VOLUME 2 OF 2 - ZONING

Summary of Comments on P:\Projects\1216-00\BIM\Revit \Families\TITLEBLOCKS\EXTELL Proposal_atwalj.pdf

Summary of Comments on AAI-TWR-ARCHITECTURE-CANTILEVER_namrudl.rvt

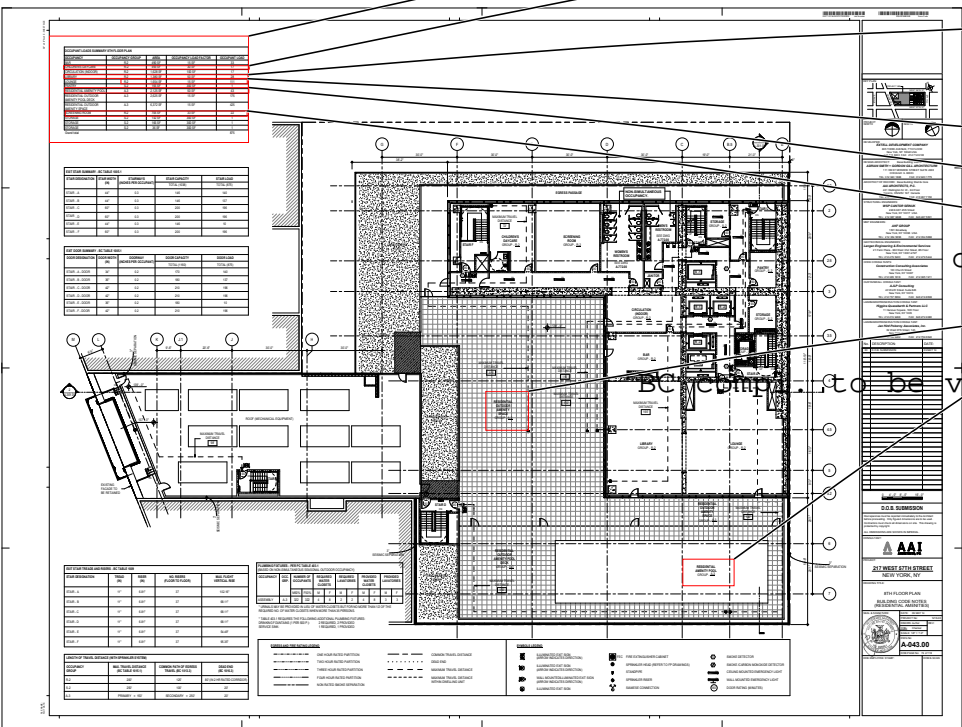
open Provide the required number of exits per space, per maximum occupant load as per Table 1014.1.

Author: dtitus Subject: Rectangle Date: 10/7/2014 8:28:30 AM
Provide exit signs as per BC 1006, BC 1011, BC 1026 (both EG and Construction plans) 11-18-14

Author: dtitus Subject: Rectangle Date: 10/7/2014 8:45:47 AM
Propose swimming pool not located within a building does not meet the requirements of ZR 12-10 accessory use (5), (ii).

Author: dtitus Subject: Rectangle Date: 10/7/2014 9:10:59 AM
one space A- occupancy.

Author: dtitus Subject: Rectangle Date: 10/7/2014 9:12:42 AM
owers not permitted if acc. to R occupancy.

11-18-14 pool below roof line.

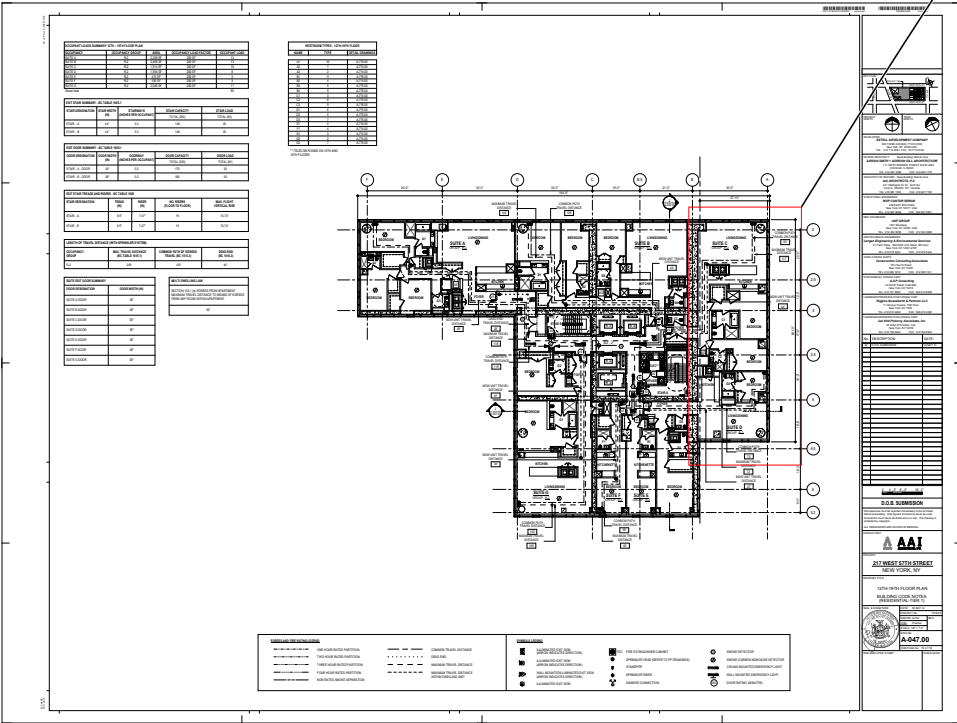
- BC 1101.1, 1101.2, and
ICC/ANSI A117.1-2003 Verify compliance with accessibility as per BC 1101
1.Doors & maneuvering clearances-1107.2.1
2.Residential bathrooms – 1107/ Appendix P
3.Residential kitchens – 1107.
4.Show all grab-bars including vertical as per P102.8.3.1,
5.Walk-in closets
6.Access to W/D within units (Where washing machines or clothes dryers are provided within the dwelling or sleeping unit, such equipment shall comply with Section 611 (Washing Machines and Clothes Dryers) of ICC A117.1 and shall be front loading. Laundry equipment in accessible common-use areas as required in Section 1107.3 shall comply with Section E105.3. (TYP ALL R-2 Floors)

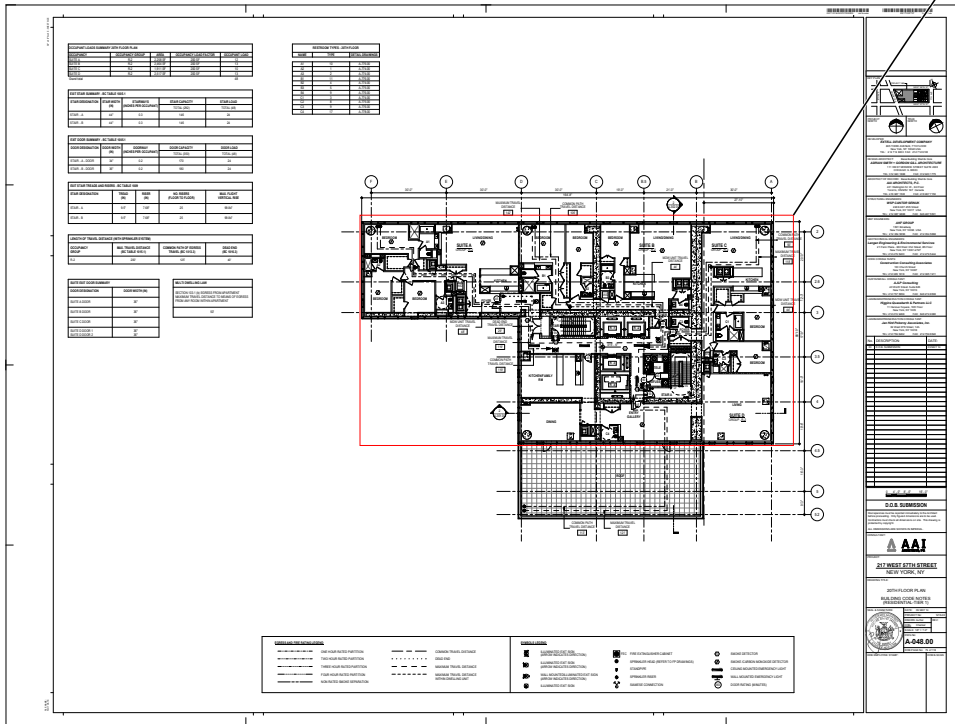
- BC 1101.1, 1101.2, and
ICC/ANSI A117.1-2003 Verify compliance with accessibility as per BC 1101
1.Doors & maneuvering clearances-1107.2.1
2.Residential bathrooms – 1107/ Appendix P
3.Residential kitchens – 1107.
4.Show all grab-bars including vertical as per P102.8.3.1,
5.Walk-in closets
6.Access to W/D within units (Where washing machines or clothes dryers are provided within the dwelling or sleeping unit, such equipment shall comply with Section 611 (Washing Machines and Clothes Dryers) of ICC A117.1 and shall be front loading. Laundry equipment in accessible common-use areas as required in Section 1107.3 shall comply with Section E105.3. (TYP ALL R-2 Floors)

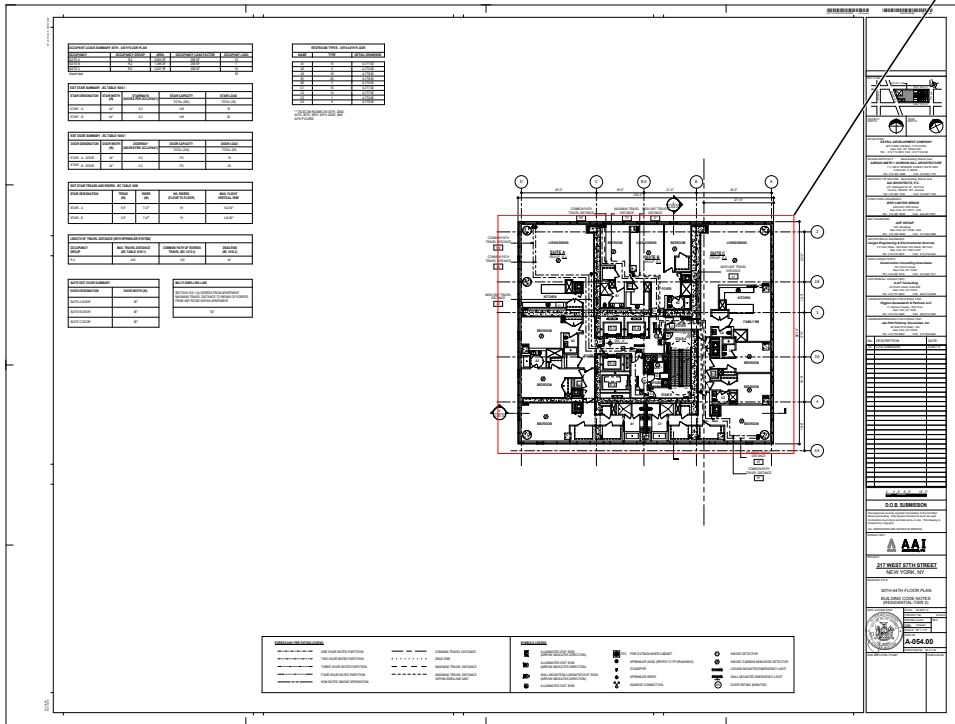
Sufficient proof must be provided for entire fa deducted. Provide layout of heavy equipment for each floor in consideration to qualify for deductions.
